HISTORIC LANDMARK COMMISSION
STAFF REPORT

Mensink House

Legalization/Appeal PLNHLC2008-227931

October 1, 2008

Attachment A
Submittal

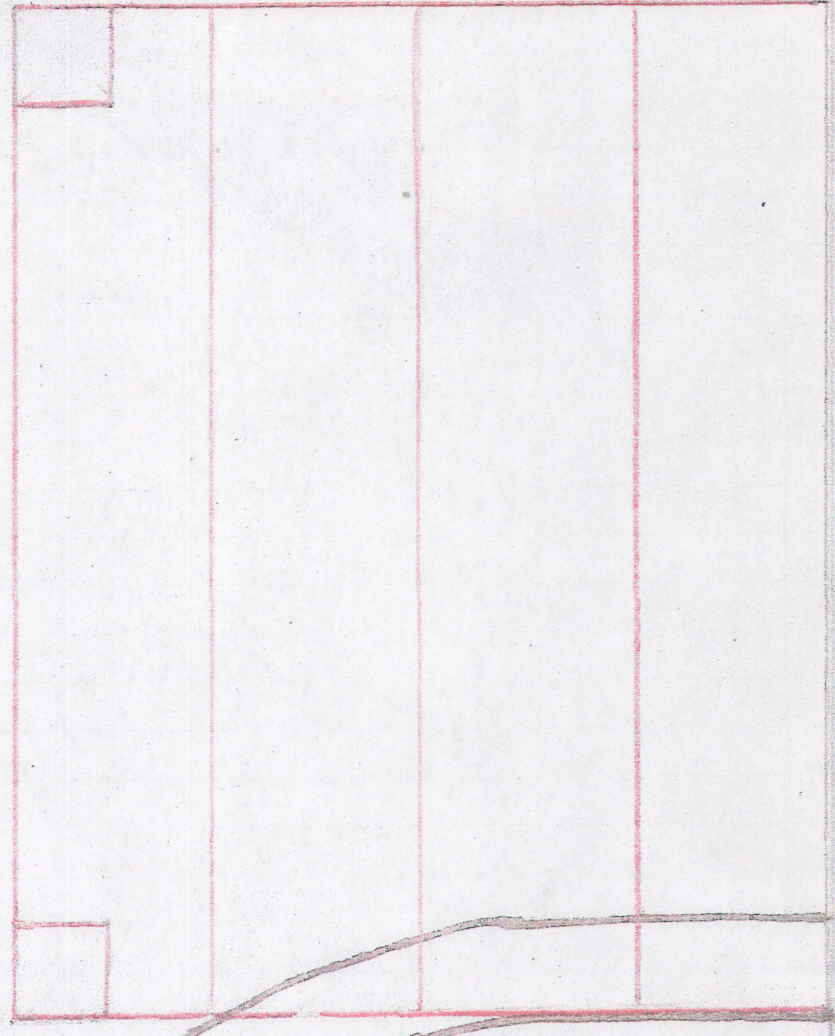
Option 1 - Straight run stairs. The applicant has submitted revised drawings in response to the discussion that occurred during the Historic Landmark Commission's September meeting. The straight run orientation of the stairs as shown on the drawings is consistent with the Commission's direction and historic photographs of the building. Greater detail is needed to fully evaluate how the stairs would blend with the angle of the walkway. Based upon discussions with Permits Counter staff; however a three foot (3') landing would be needed that follows the direction of travel of the stairs.

Staff recommends that the Commission approve a concrete winder design for the porch stairs since it would not require significant changes to the existing historic walkway. Although not an exact reproduction of the missing historic features, the proposed alterations are compatible with the character-defining features of the historic building and similar in design to other homes of the same period and style. The applicant is not seeking to create a false sense of history, but is attempting to enhance the building's appearance.

STAIR DETAIL
AT CENTER
OF
STEPS

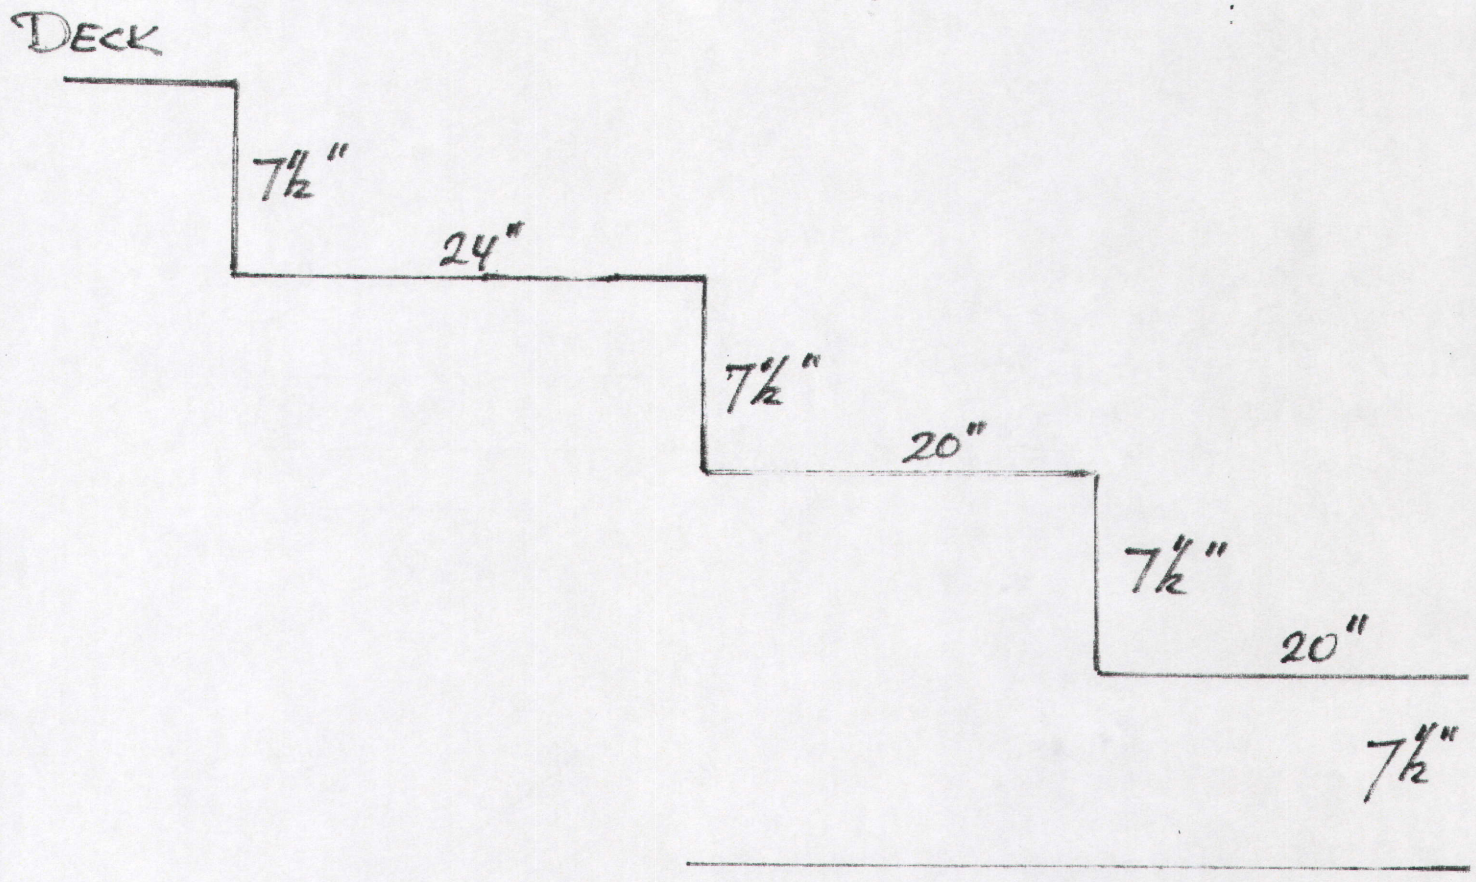
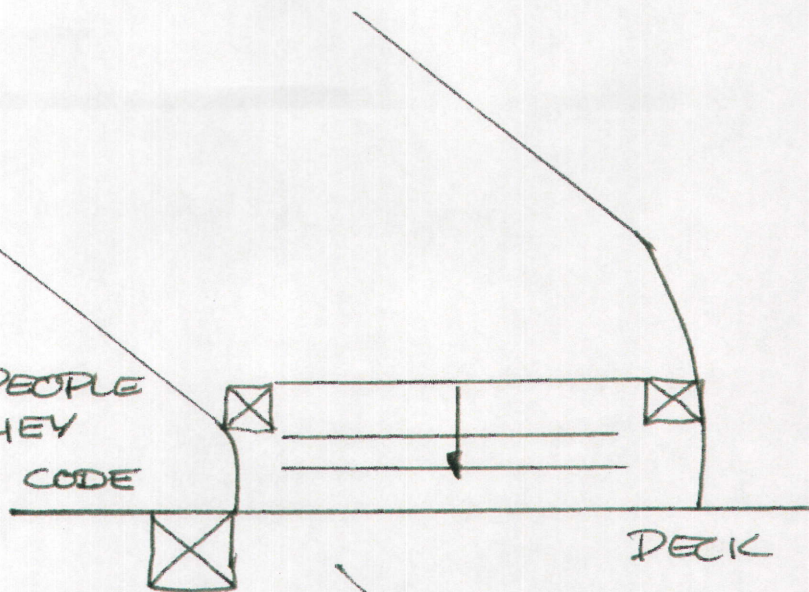
Riser height. The maximum riser height shall be 7¾ inches. The greatest riser height within any flight of stairs shall not exceed the smallest by more than ⅜ inch. *The existing risers vary in height from 7½ inches of the middle two steps to 9¾ inches at the deck level and fail to meet aforementioned*

Tread depth. Winders refer to the triangular treads which are used to conserve space when a stairway changes direction. Winder treads must have a minimum tread depth of six inches (6") at any point. Additionally, the largest winder tread depth at the twelve inch (12") walk line shall not exceed the smallest by more than $\frac{3}{8}$ inch. *The existing treads vary in depth from 12 inches to 20½ inches and fail to meet the requirements of the code relating to tread variation.*

Finding: Planning Staff's analysis regarding the design of the existing winders has not uncovered additional information that warrants support of the request to legalize the completed work. In fact, the work does not meet building code requirements and it would be difficult to readjust the existing proportions of the dimensions of the risers and treads to meet the code.
